REGIONAL REVIEW NOTIFICATION

ARC REVIEW CODE: R1806191

Name of Proposal: Project Rocket (DRI 2807)

PROJECT ROCKET DRI 2807
Gwinnett County
ARC Natural Resources Group Comments
June 15, 2018

DRI PLAN

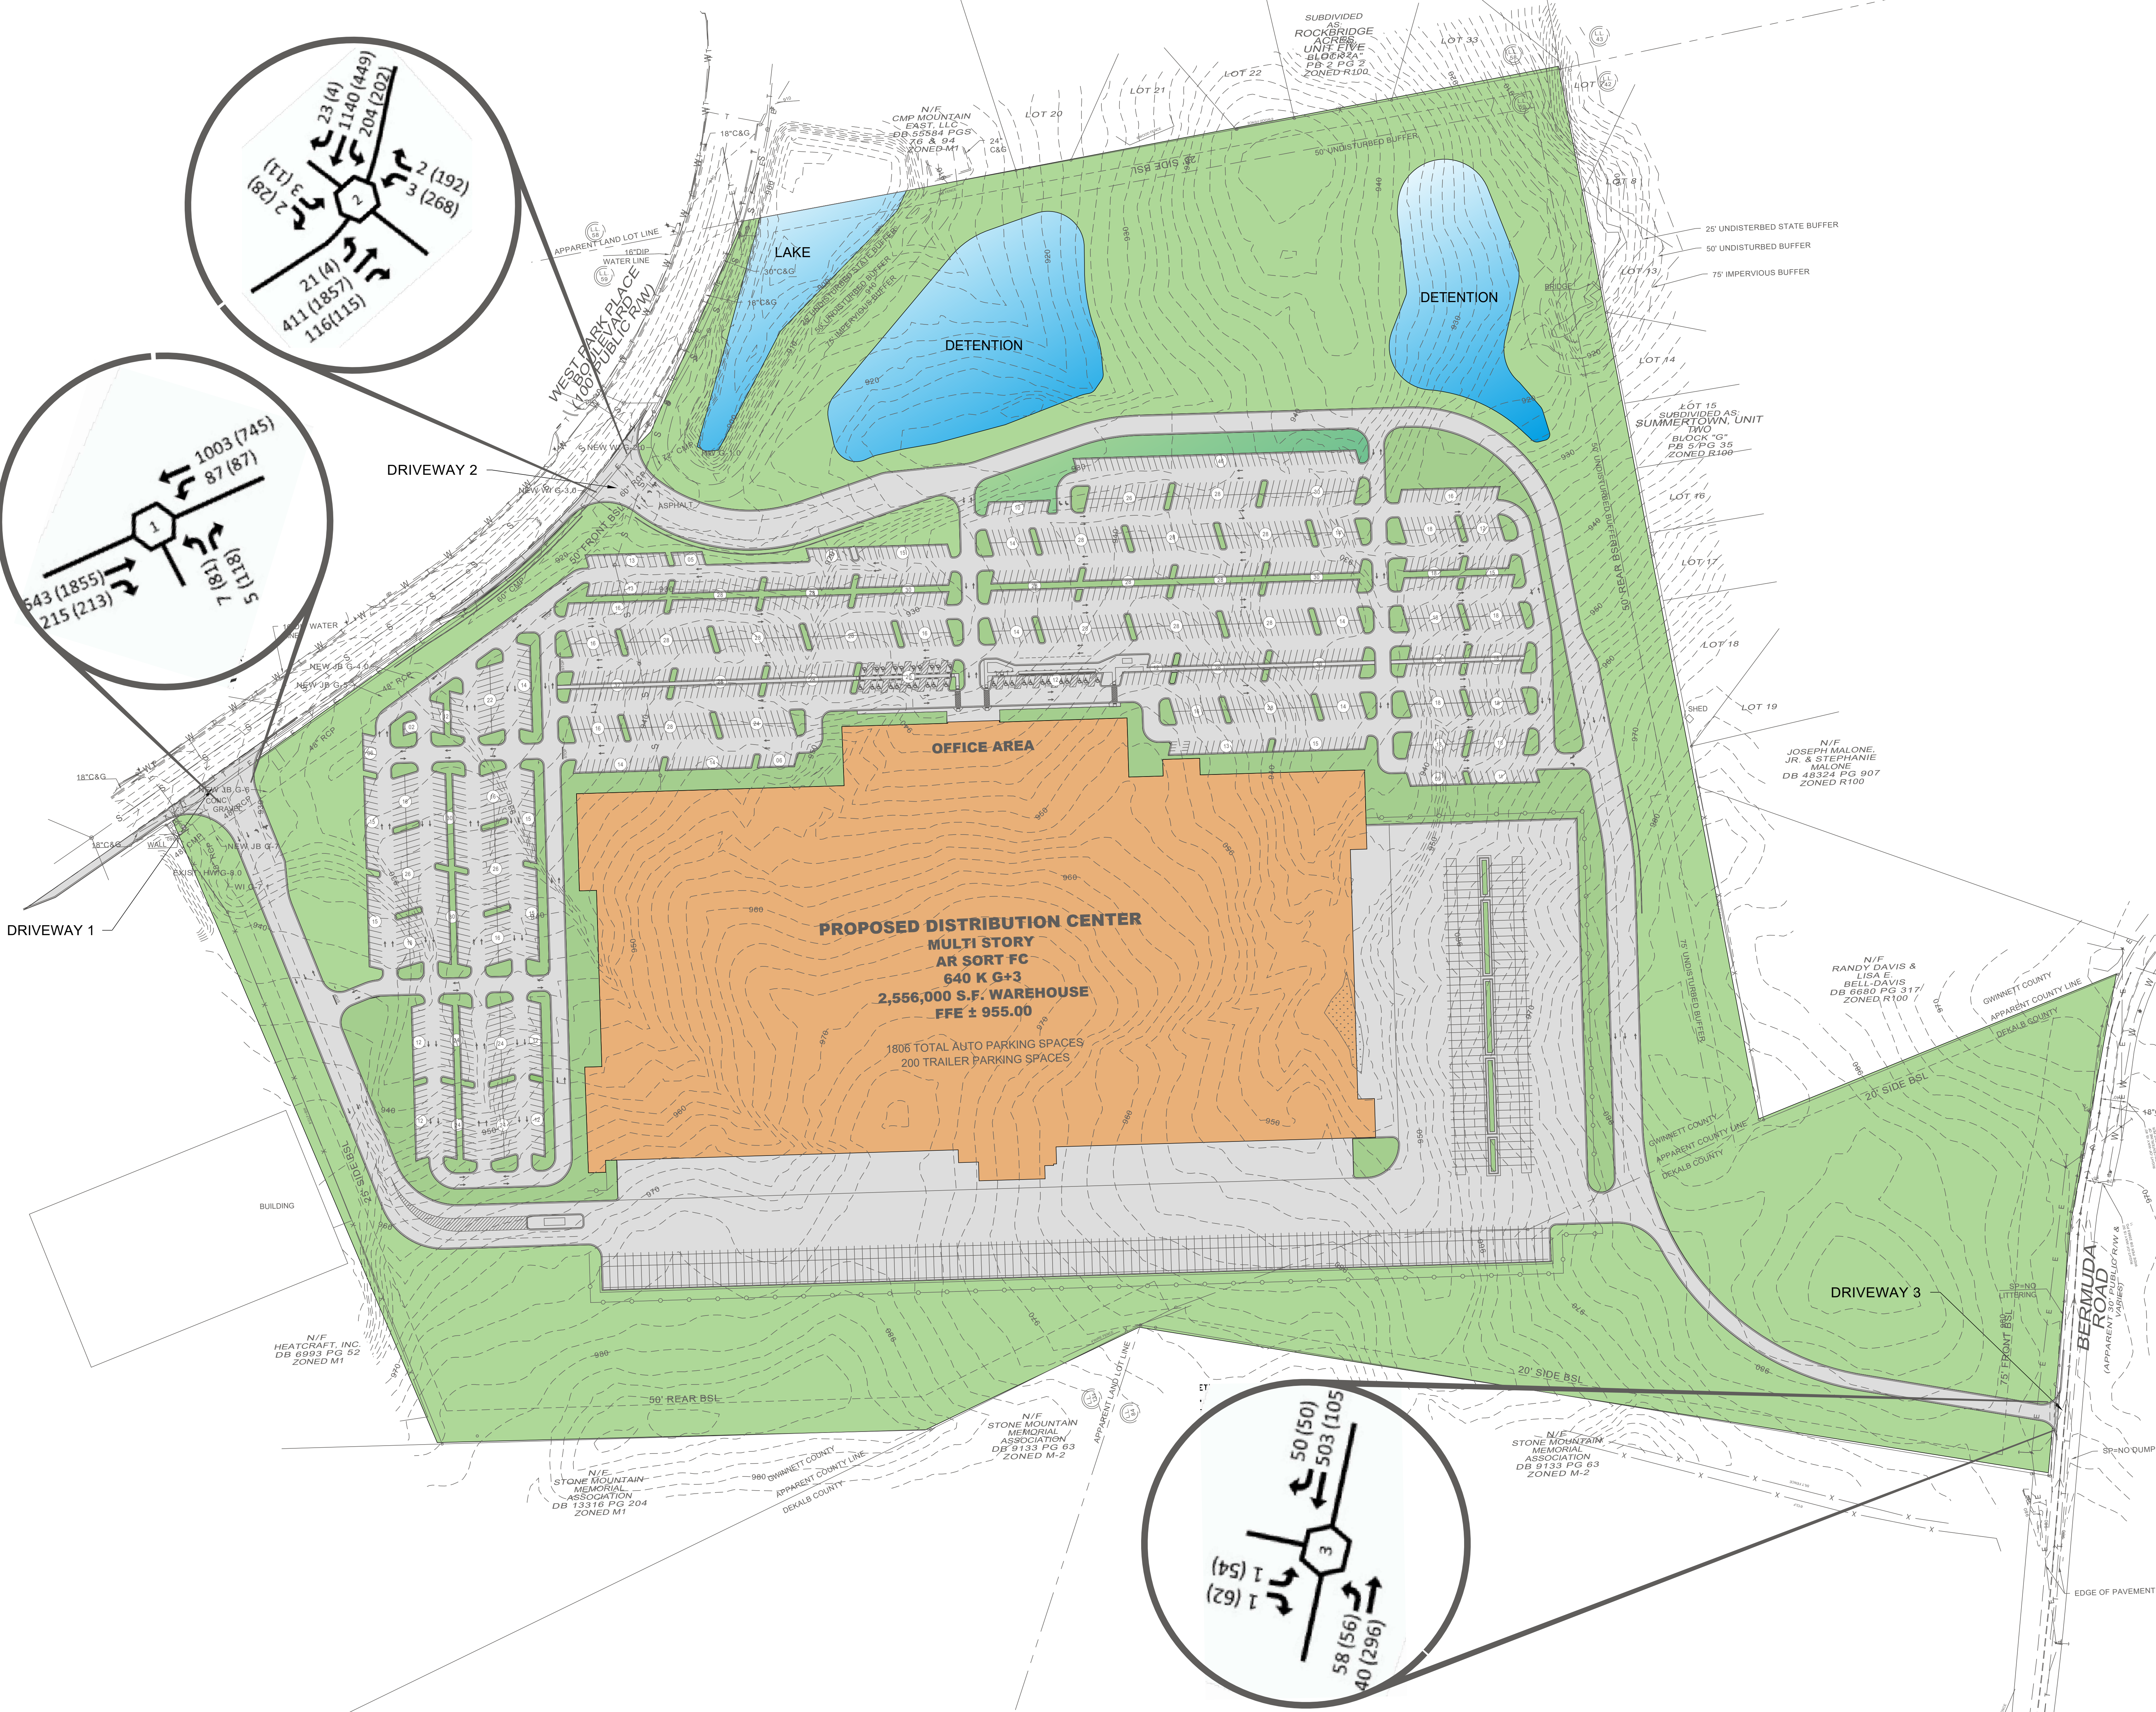
The development proposes industrial uses adjacent to undeveloped property designated for residential and industrial uses. The development does not propose stub outs for connectivity with adjacent parcels, however, connections may be made through local roads.

The development proposes sidewalks and pedestrian facilities along Bermuda Road and West Park Place Road adjacent to the site. Due to the nature of the use of the development, limited sidewalks are proposed.

The site plan depicts sidewalks along both Bermuda Road and West Park Place Road adjacent to the site. No bicycle facilities or internal pedestrian connections are proposed.
